**London Borough of Wandsworth**  
**Local Plan Consultation - Proposed Main Modifications**  
3rd February 2023 to 17th March 2023

**Local Plan Consultation - Proposed Main Modifications**

**Map 3.2 Site Allocations**

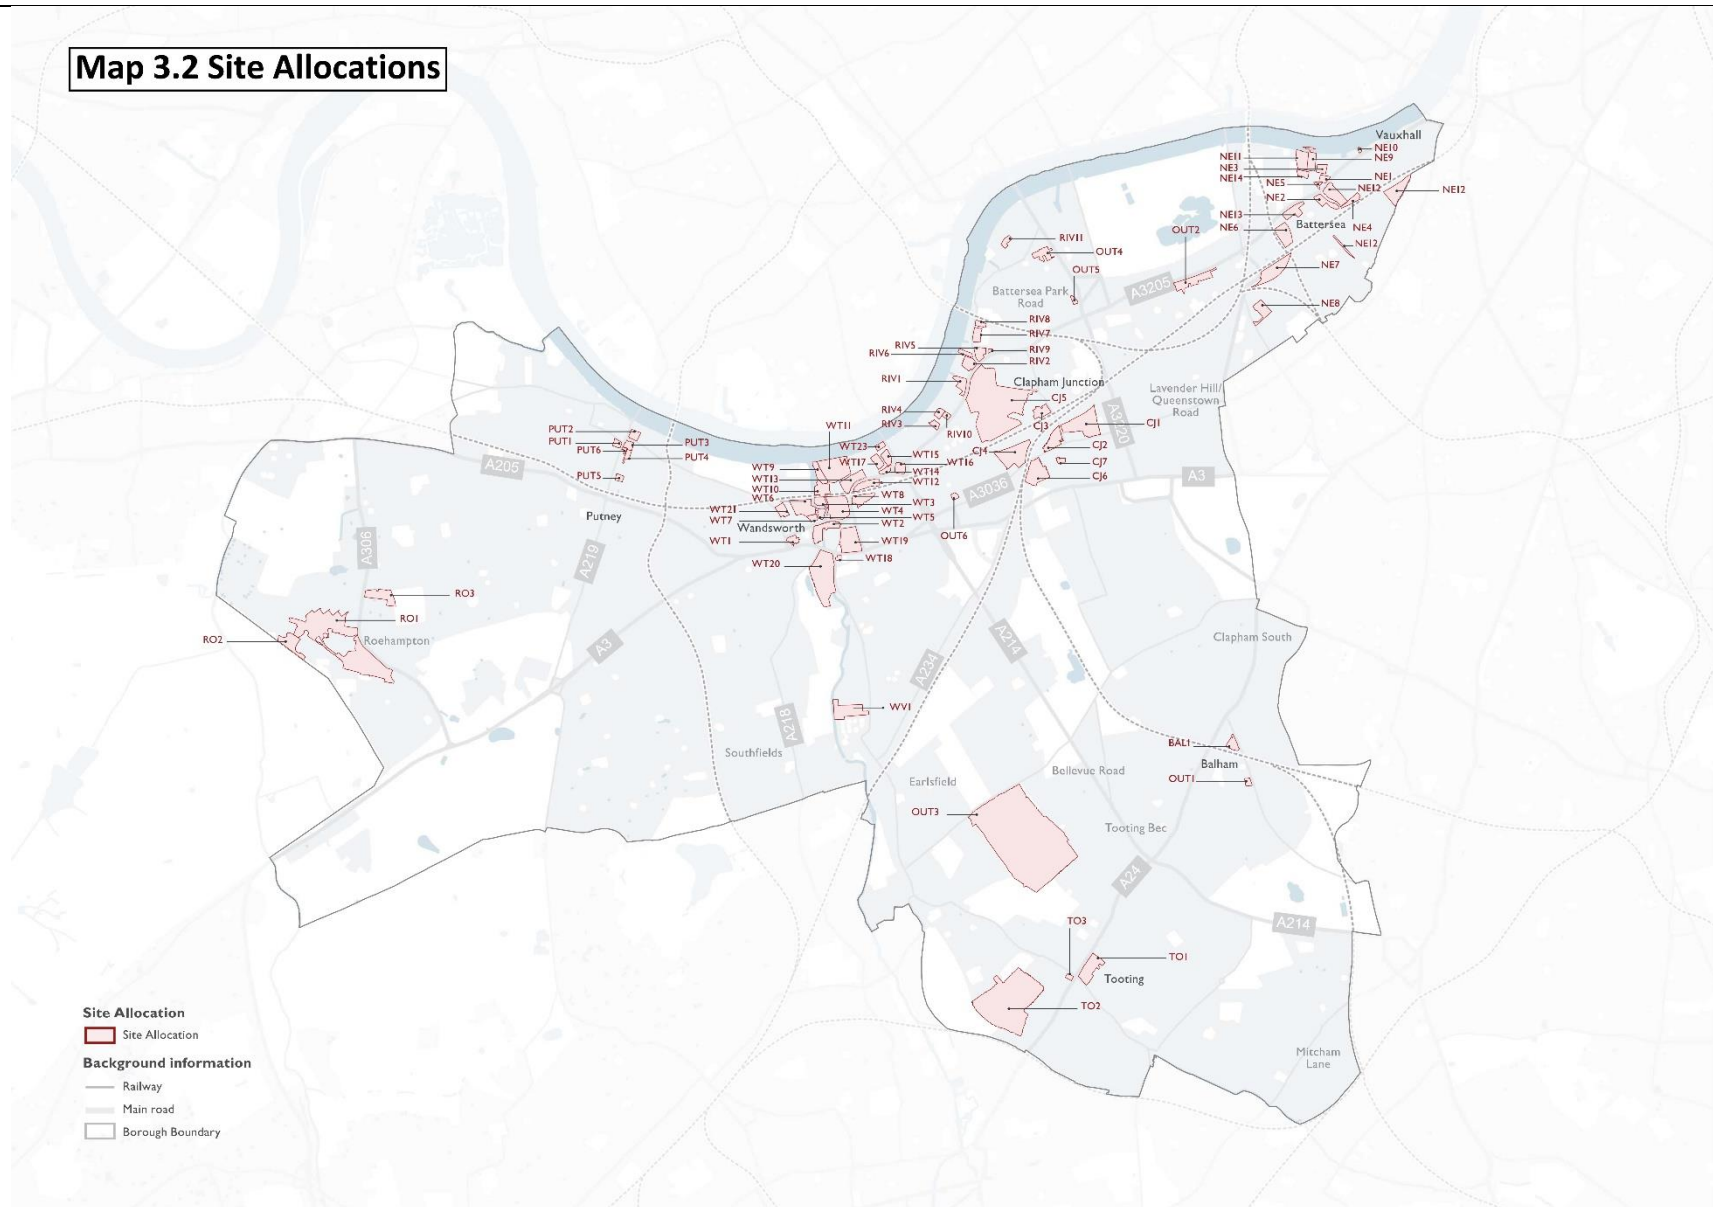
Amend the boundary to 'NE6 Havelock Terrace' to remove area north of Palmerston Way.	To correctly identify the area of significance to the site allocation.	In response to the GLA to ensure general conformity with the London Plan policies E4 and E7.
		Update boundary for WT11 Western Riverside Waste Transfer Station to include the Household Waste and Recycling Centre to the east.	In response to comments from the Western Riverside Waste Authority regarding accuracy of land ownership and operation the Household Waste and Recycling Centre.	As a result of Reg 19 Reps and the Statement of Common Ground with the Western Riverside Waste Authority.

Map 4.1 Spatial Area Map: Wandsworth Town

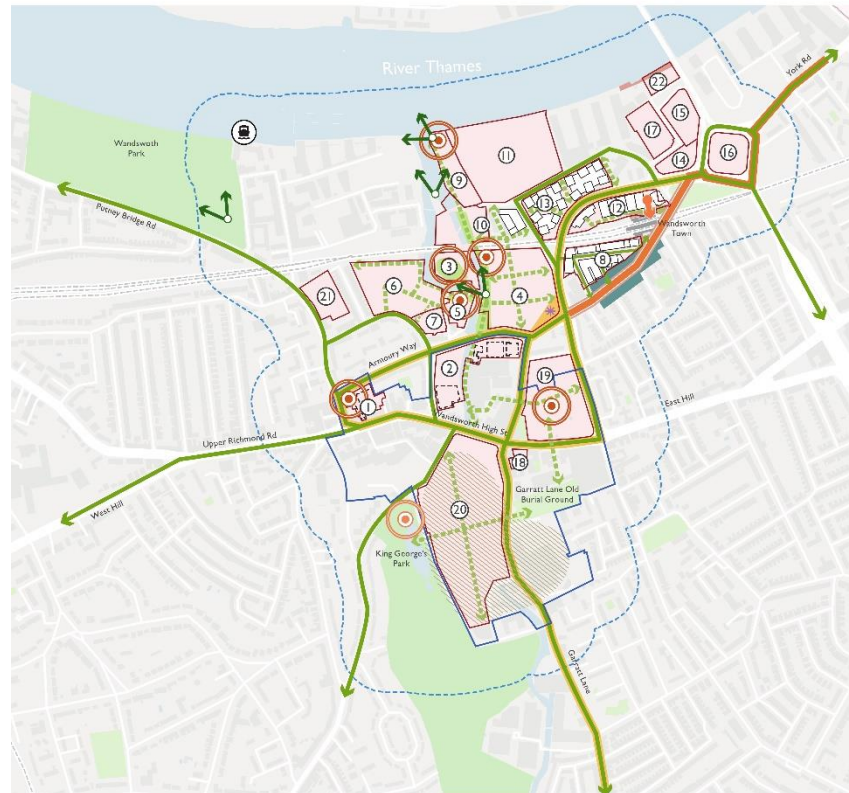
MM9	Map 4.1 Spatial Area Map: Wandsworth Town	Remove 'Proposed New Public Open Space' (Green shape) from WT9 Feather's Wharf.	To correct an illustrative error as the map already identifies an area of open space at the very north of the site.	As a result of Reg 19 Reps and the Statement of Common Ground with the Western Riverside Waste Authority.
		Update boundary for WT11 Western Riverside Waste Transfer Station which includes the Household Waste and Recycling Centre to the east.	It is recognised that there is merit in extending the boundary to the east to include the remainder of the Safeguarded Wharf	As a result of Reg 19 Reps and the Statement of Common Ground with the

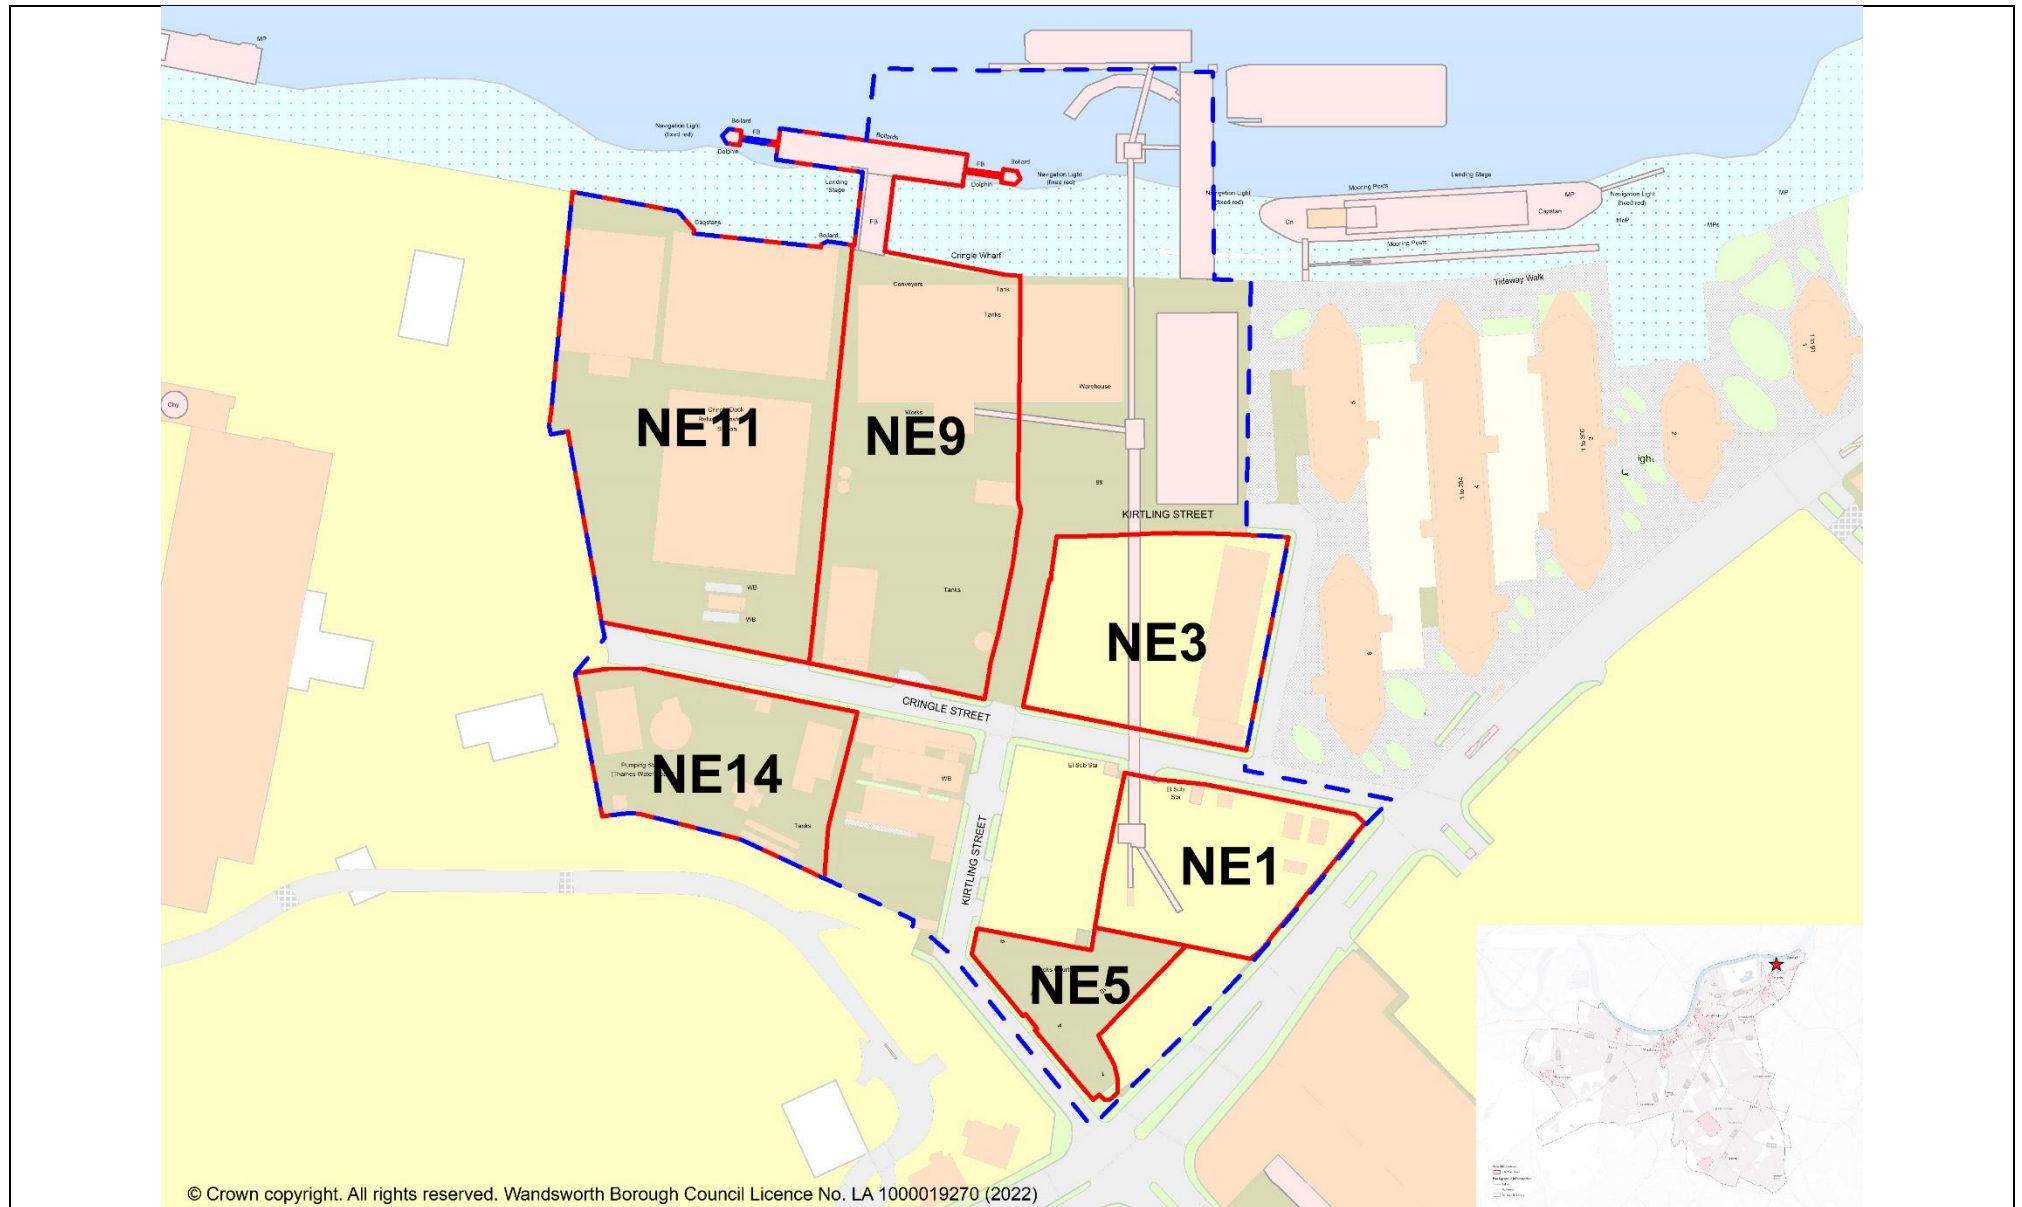
MM55	Map 5.5 Kirtling Street Cluster	Include boundary and key for new site allocation NE14 Battersea Ring Main Site, south of NE11 and Cringle Street and east of Battersea Power Station, west of Kirtling Street and north of Pump House Lane. Amend cluster boundary to include this site allocation.	New site allocation NE14 is proposed in response to Thames Tideway Reg19 comments as a new development site, in recognition of a previously unidentified suitable site allocation to complement	As a result of Reg 19 Reps and the Statement of Common Ground with the Thames Tideway.

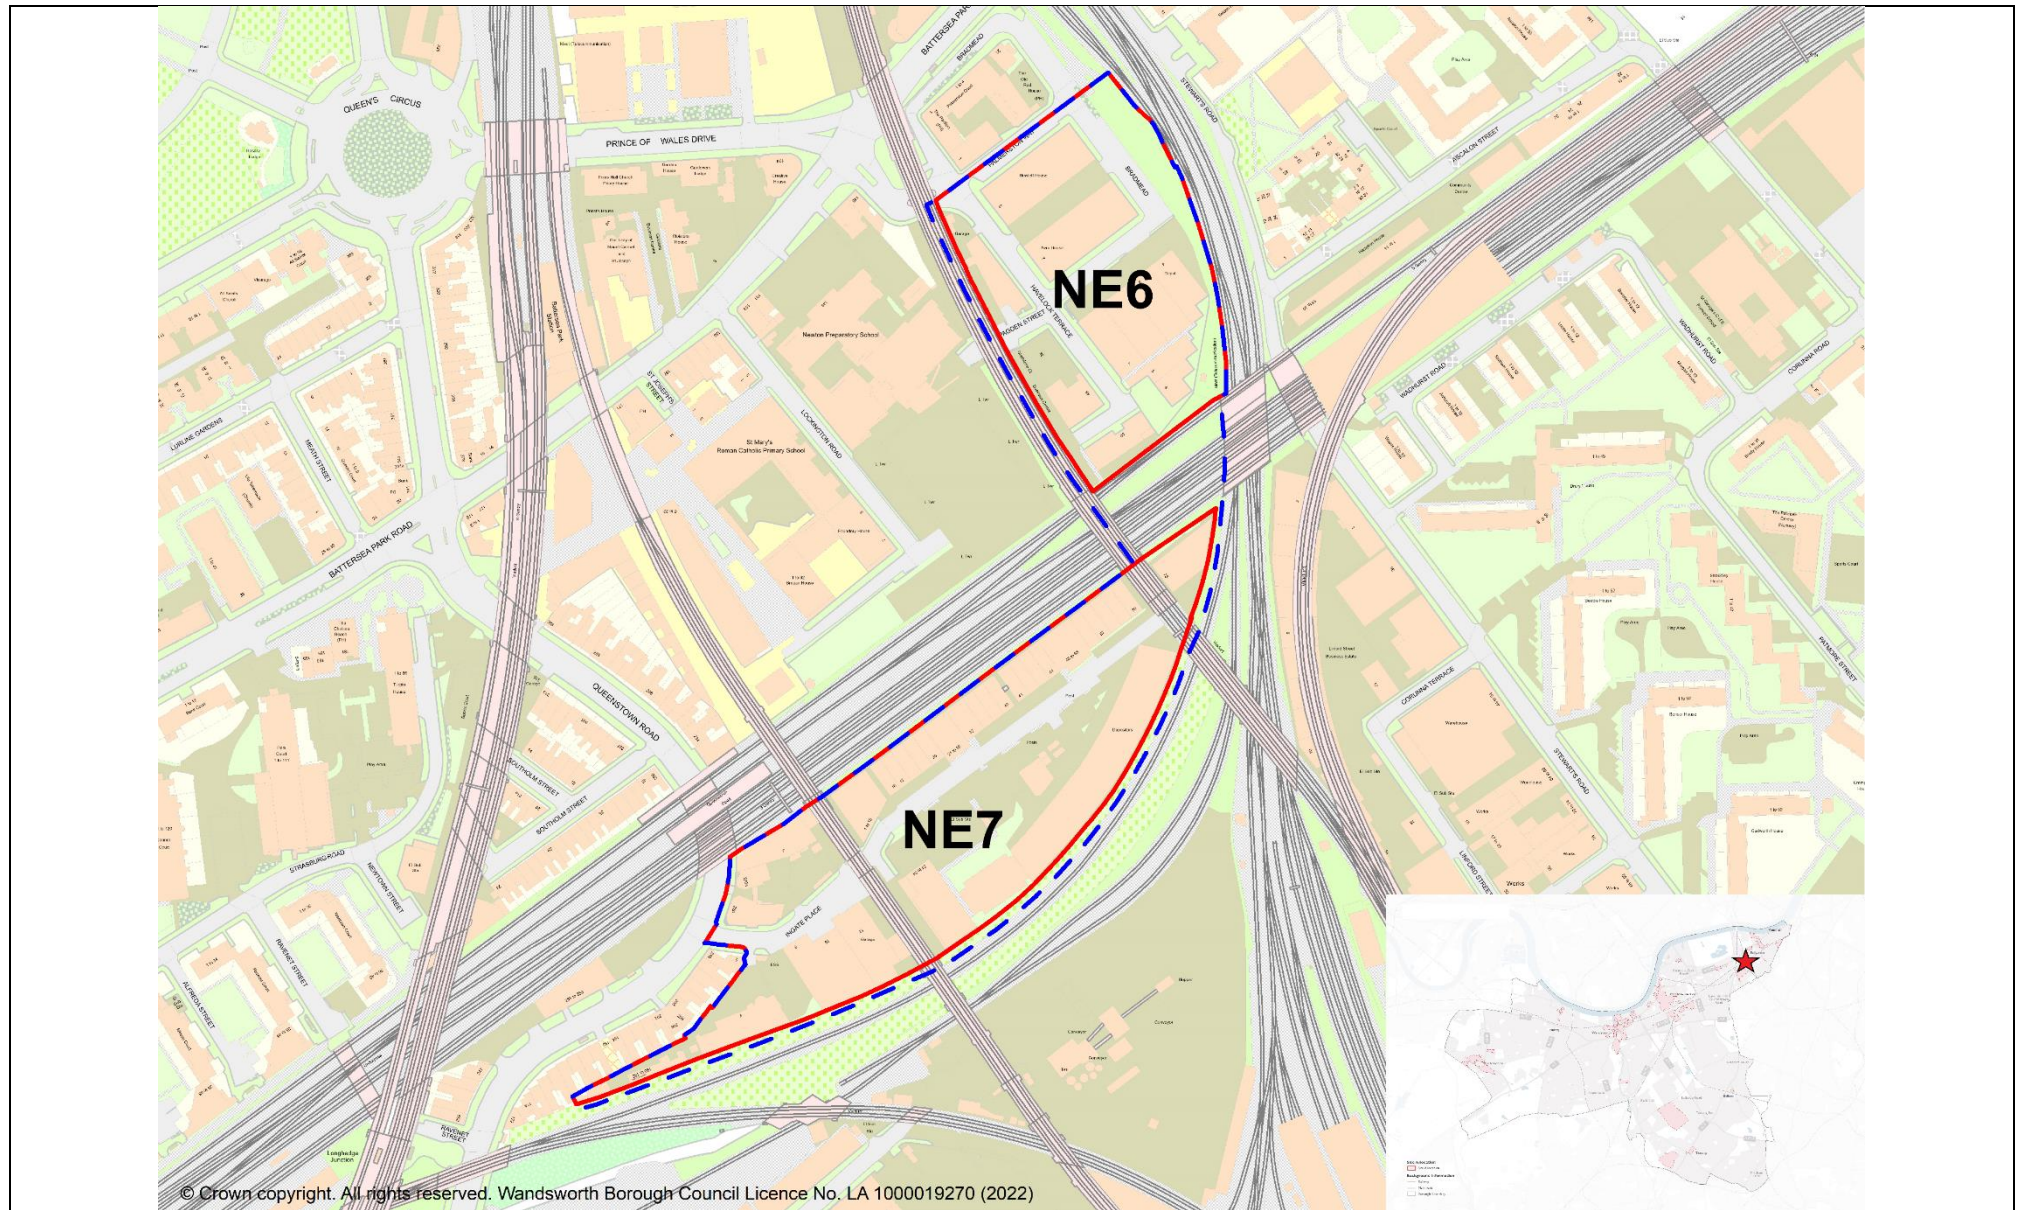
MM59	Map 5.7 Battersea Design and	Amend boundary to ‘NE8 Silverthorne Road’ to reflect new boundary for ‘NE8 Battersea Studios’ which encompasses Battersea Studios site only.	New separate Site Allocation (new NE8 Battersea Studios) in	In response to the GLA to ensure general conformity with the

Amend map to place focus on Ingate Place NE7 and Havelock Terrace NE6.	To correctly focus on the area of importance for this map.	In response to the GLA to ensure general conformity with the London Plan policies E4 and E7.

**Map 6.1 Spatial Area Map: Clapham Junction and Winstanley/ York Road Regeneration Area**

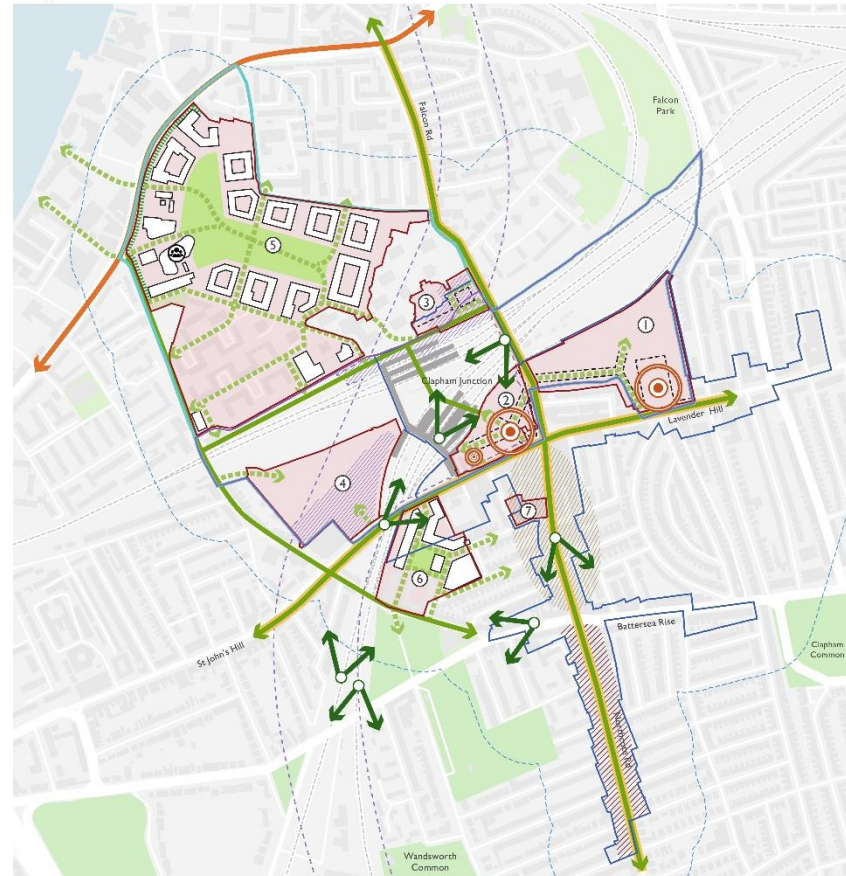
MM81	PM4 Clapham Junction and York Road/ Winstanley Regeneration Area	<p>Amend wording in PM4 Clapham Junction and York Road/ Winstanley Regeneration Area A.7 as follows:</p> <p>'Development proposals will be required to respect and enhance the <u>valued</u> views and vistas established in <u>Map 6.1 Spatial Area Map: Clapham Junction and York Road/ Winstanley Regeneration Area</u>. <del>the Urban Design Study (2021)</del>'</p>	To ensure there is greater clarity as to which views are considered as part of the development process by removing the consideration of the views analysis of the Urban	As a result of Reg 19 Reps.

Main Modification Number	Section of the Plan	Proposed Main Modification	Justification	Reason for change
			Design study which is not considered to be robust.	
MM82	Map 6.1 Spatial Area Map: Clapham Junction and Winstanley/ York Road Regeneration Area	Amend key to retitle as follows: 'Clapham Junction <del>Urban Heart</del> Station Masterplan Boundary'	To clarify the correct title of the Masterplan.	As a result of Reg 19 Reprs.
		Switch the numbers '3' and '4' over site allocations CJ3 and CJ4.	To correct inaccuracy.	As a result of Reg 19 Reprs.

**Map 6.1 Spatial Area Map: Clapham Junction and Winstanley/ York Road Regeneration Area - Inset Map**

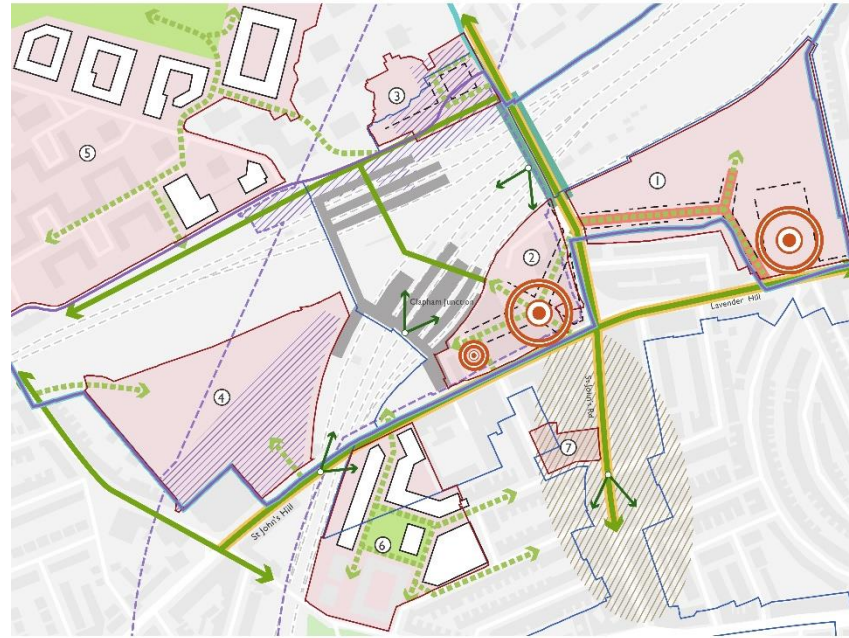
Main Modification Number	Section of the Plan	Proposed Main Modification	Justification	Reason for change
MM83	Map 6.2 Spatial Area Map: Clapham Junction and Winstanley/ York Road Regeneration Area - Inset Map	Amend key to retitle as follows: 'Clapham Junction <del>Urban Heart</del> Station Masterplan Boundary'	To clarify the correct title of the Masterplan.	As a result of Reg 19 Reps.
